MJ11/MM11

TECHNICAL
INFORMATION
DEC CONFIDENTIAL

EP-MJ11-00-TI-A

JAN 1977

MM115 REWORK SHEET

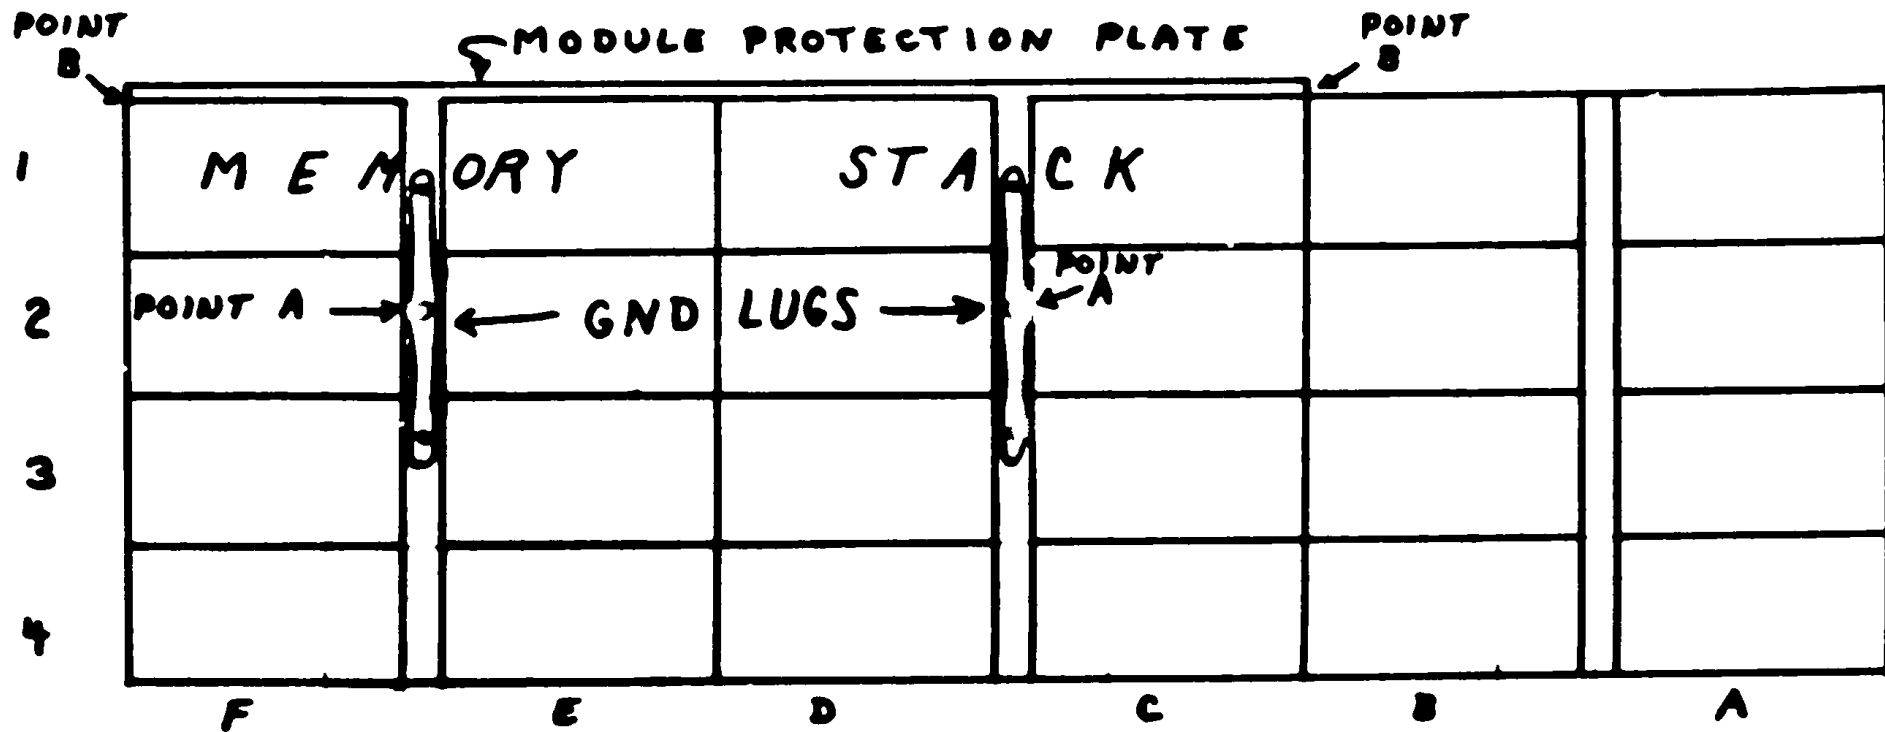
NOTES This FCO is required when other options such as KW1-P, etc. are physically mounted next to an MM1-S memory. Noise generated by the MM1-S may interact with adjacent modules.

Q1 74-08490 Module protection plate
